| APPLICATION NO. | FILING DATE | FIRST NAMED INVENTOR | ATTORNEY DOCKET NO. | CONFIRMATION NO. |
|-----------------|-------------|----------------------|---------------------|------------------|
| 10/507,453 | 09/13/2004 | Gerd Reime | REP-0027 | 1401 |

Office Action Summary

DETAILED ACTION

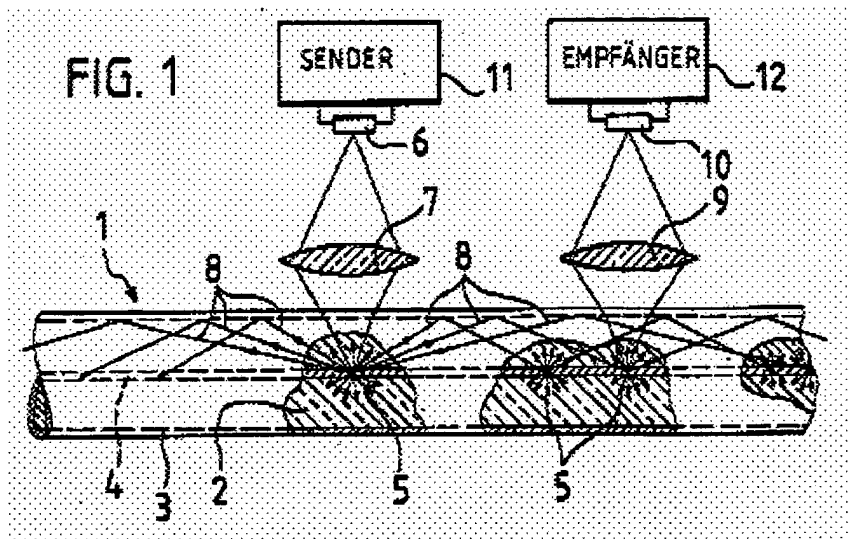
With respect to claims 26, 40 and 41, Walter et al. (figure 1) disclose a device for optoelectronically detecting movement and/or position of an object comprising at least one transmitting element (11) for emitting radiation in the optical wavelength range and at least one receiving element (12) for receiving at least a part of the radiation emitted by the transmitting element and reflected back by the object and also comprising an optical guide (1) arranged in the beam path between the transmitting element and the receiving element (see figure 1), wherein the optical guide (1) comprises at least one light coupling element (2) for at least one of coupling-in the radiation previously radiated through the optical guide (1) and diffusely scattered at the object transversely to the longitudinal extent of the optical guide, and coupling-out radiation radiated to the optical guide by the transmitting element transversely to the longitudinal extent of the optical guide; wherein signals derived by the at least one receiving element are used as input for a writing recognition system and the at least one transmitting element (11) remains illuminated after a key associated therewith is actuated (see figure 1 and the abstract).

With respect to claims 28 and 29, Walter et al. (figure 1) disclose the device, wherein the radiation radiated through the optical guide (1) by the transmitting element (11) is radiated transversely through the optical guide from the side opposite the object and wherein radiation emitted along the optical guide (1) by the transmitting element (11) is at least partially coupled-out of the optical guide by the at least one light coupling element (2) before it is scattered by the object.

With respect to claim 30, Walter et al. (figure 1) disclose the device, wherein the at least one light coupling element (2) is a forming at the side of the optical guide facing away from the object transversely approaching the optical guide (1).

With respect to claims 31 and 33, Walter et al. (figure 1) disclose the device, wherein the optical guide (1) comprises a plurality of light coupling elements (2) which are spatially associated with a respective transmitting element (11) and wherein the transmitting elements are arranged in the form of a keyboard and in that a curved or circular-segment-shaped light coupling element is associated with each key (see figure 1).

With respect to claims 38 and 39, Walter et al. (figure 1) disclose the device, wherein a plurality of light coupling elements (2) is arranged in the form of a matrix or a circle (see figure 1).
